UNITED STATES
NUCLEAR REGULATORY COMMISSION
WASHINGTON, D. C. 20555

SUBJECT: SEISMOLOGICAL INPUT PARAMETERS FOR USE IN ARMY
CORPS OF ENGINEERS (COE) GEOTECHNICAL REVIEW
OF MIDLAND 1 AND 2

SUBJECT: TRIP TO THE MIDLAND 1 AND 2 SITE

FIGURE 17.—Tracings of accelerograph records obtained at San Francisco, Alexander Building, basement and 11th floor, on March 22.

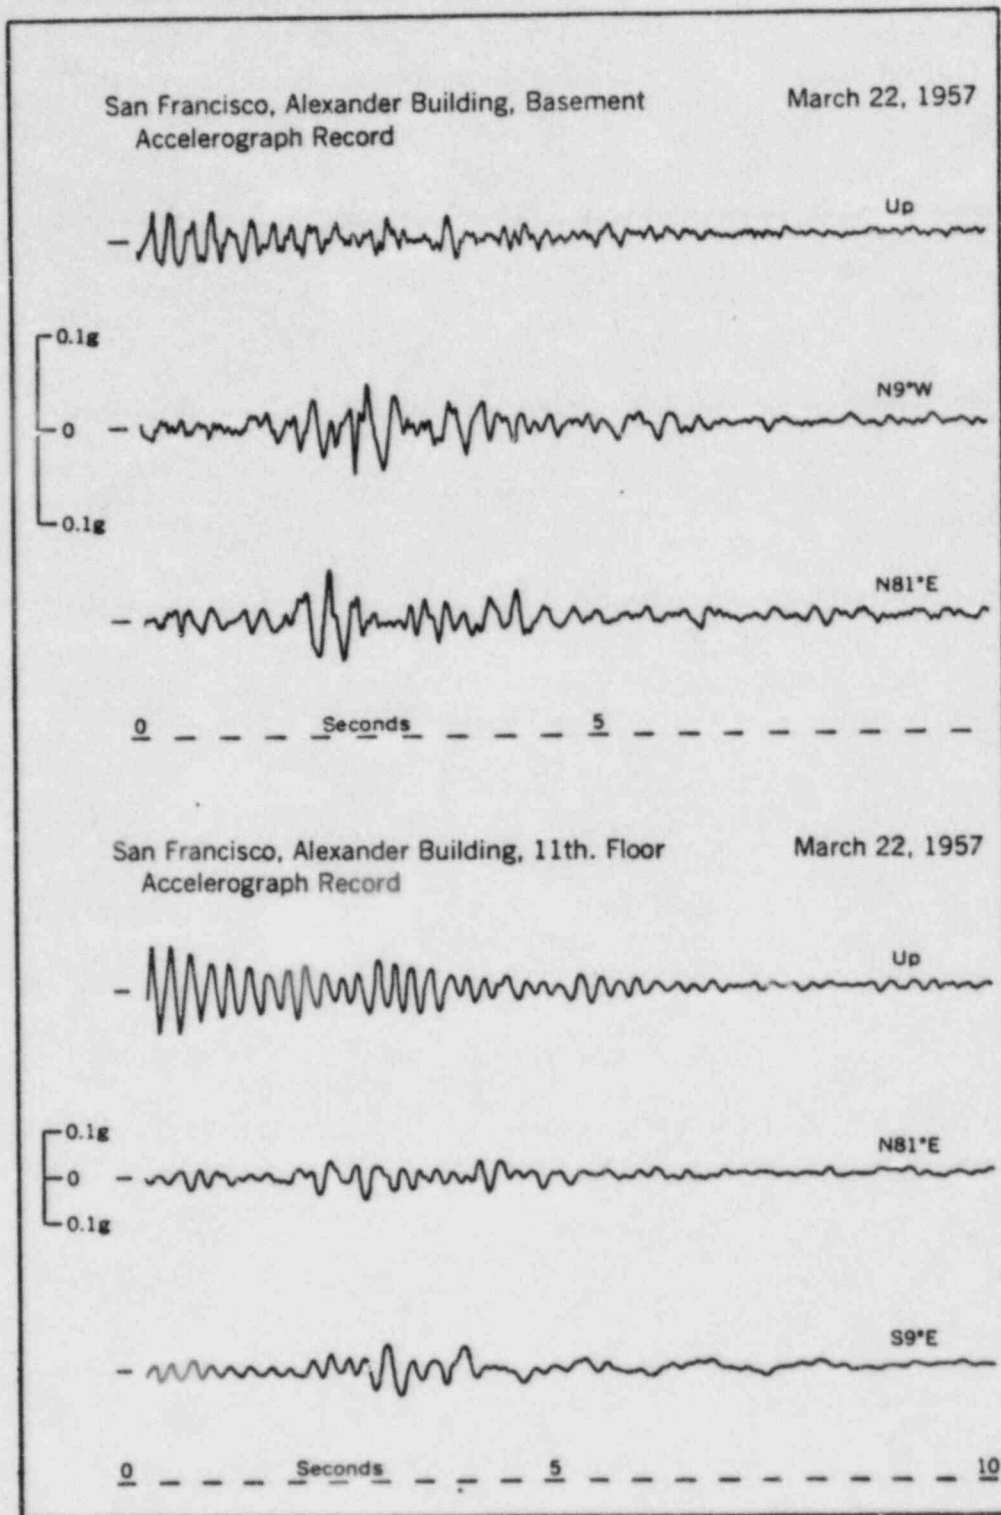
+EARTHQUAKE		Recording Site				Reference Information			
LOCATION	DATE	MAG	Max. Horiz. Accel.	Distance KM		Soil Depth	Soil	SW-AA	
✓ San Francisco, CA NO	3/22/57	5.3	0.046g	15	Alexander Building, SF	Cal Tech A014	140'	Still Soil	115' clayey silty sand over bedrock
✓ San Francisco, CA (OK)	3/22/57	5.3	0.085g	17	State Building, San Francisco	Cal Tech A016	200'	still Soil	200' of sand over bedrock
✓ San Francisco, CA NO	3/22/57	5.3	0.047g	17	Southern Pacific Building, SF	Cal Tech A013		Deep soil site	
Northern, CA ?	9/4/62	5.0	0.048g	19	Eureka Federal Building	Cal Tech V330		Deep Soil Site	?
✓ Northern, CA (OK)	3/9/49	5.3	0.197g	29	Hollister Public Library	Cal Tech U301		Deep Soil	
✓ Central CA No	1/19/60	5.0	0.057g	8.5	Hollister Public Library	Cal Tech U307		Deep Soil	
Lytile Creek CA NO	9/12/70	5.4	0.197g	13	Wrightwood, CA	Cal Tech U334		Rock site	
✓ Southern CA NO	3/18/57	4.7	0.167g	5.4	Pt. Hueneme Naval Res. Lab	Cal Tech V329		? Soil

FIGURE 15.—Tracings of accelerograph and displacement meter records obtained at Port Hueneme on March 18.

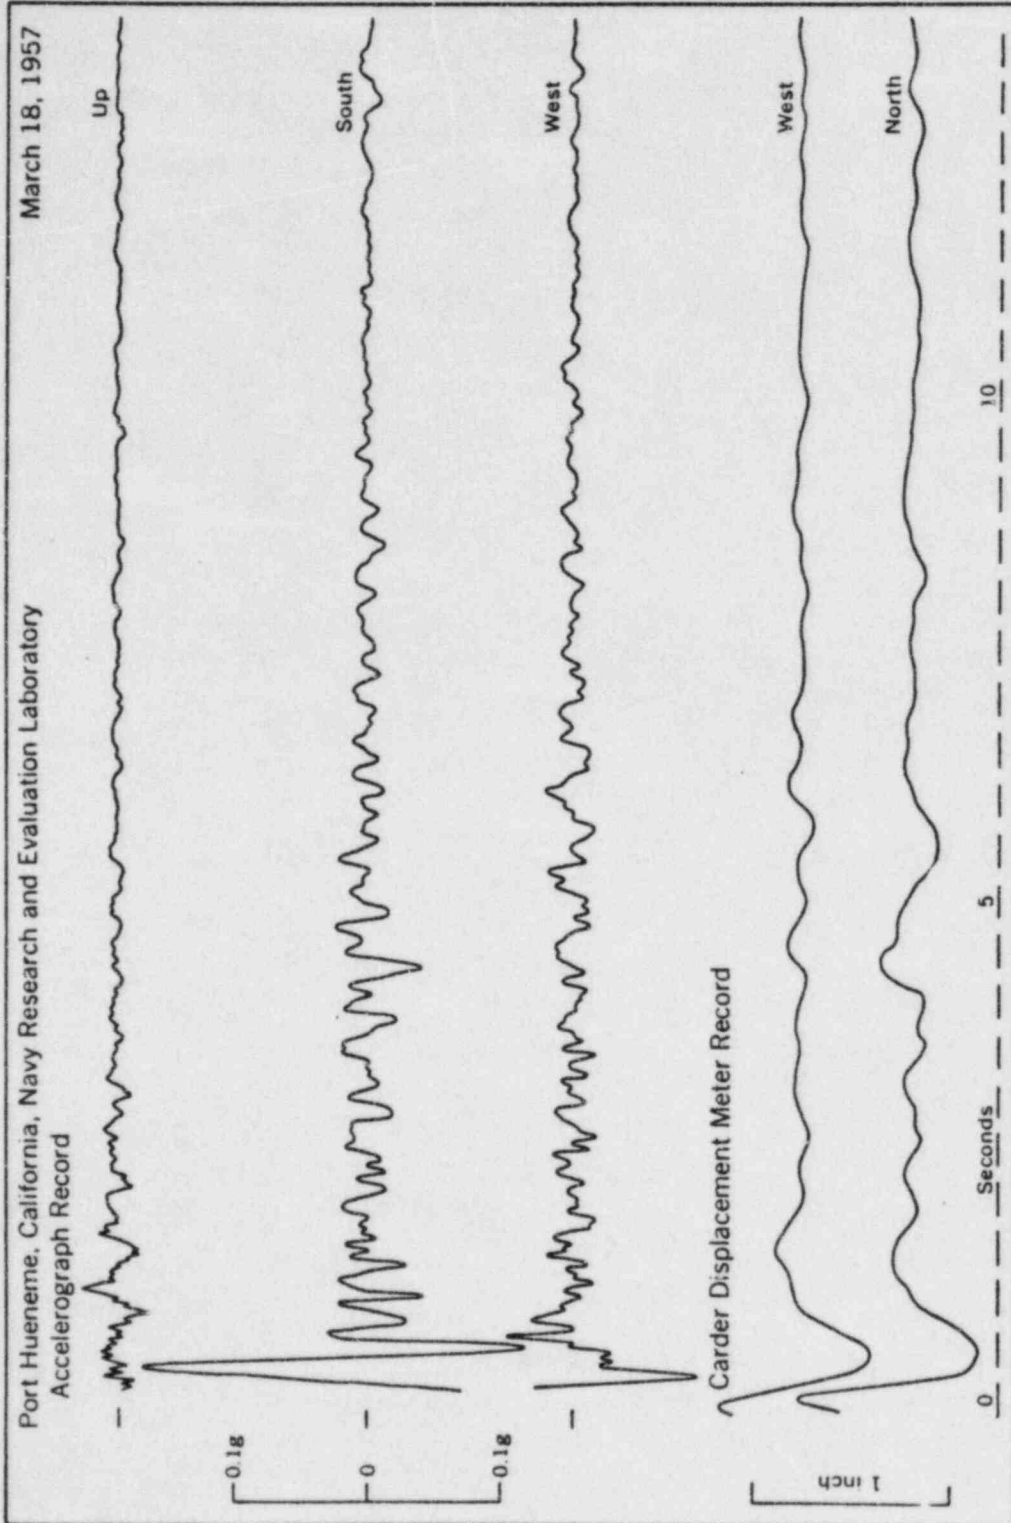
Port Hueneme Naval Research Bldg 3/18/57
